**Historical Architectural Review Board
COA Final Review Sheet**

HDC-2023-00005

Address: 937 North Street

Proposal: Install solar panels

**Array layout.
(Applicant)**

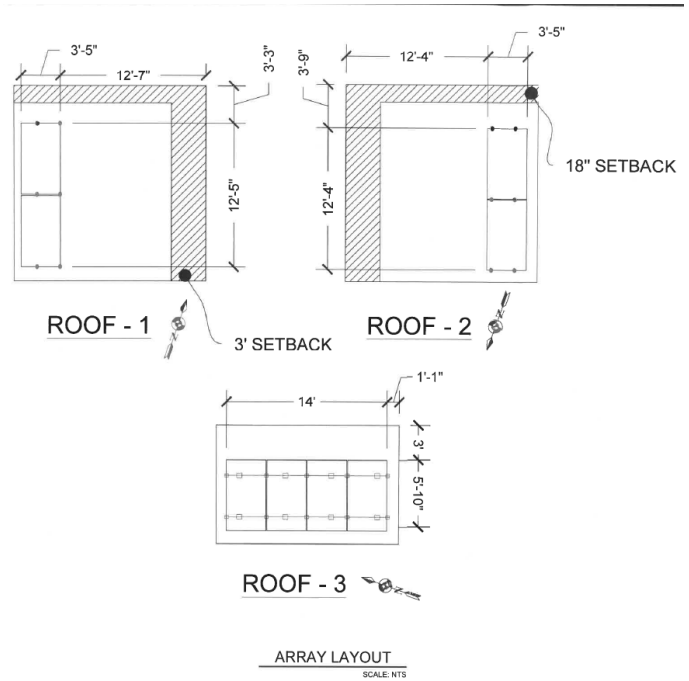
A solar panel array is proposed to be located on the west side of the dormer at the front slope and would have a 3-foot setback from the front façade. The solar panels would project 6-inches off the roof and would likely be visible from North Street. Staff recommends installing a mock-up of the proposed array at this location to determine visibility. The solar panels should be inconspicuous from the public right-of-way to comply with the guidelines.

At the rear, the property abuts Broome Street, which is a service alley that dead ends behind the building. While the solar array on the rear slope of the gable roof would be visible from the alley, this portion of the building is considered a non-contributing secondary façade and the visibility of the solar panels does not have an adverse impact on the district.

Approval, provided a mockup shows that the array on the front roof slope is inconspicuous from North Street, with the staff to review details, pursuant to Chapter 3, Section 3.10 Solar Energy and Energy Improvements.

Mr. Hart moved to approve with conditions the application presented on 2/6/2023 for the installation of solar panels at 937 North Street, with the staff to review details, pursuant to Chapter 3, Section 3.10 Solar Energy and Energy Improvements, provided a mockup shows that the solar panels proposed at the front slope are inconspicuous from the right-of-way. Mr. Encelewski seconded the motion, which carried with unanimous support.
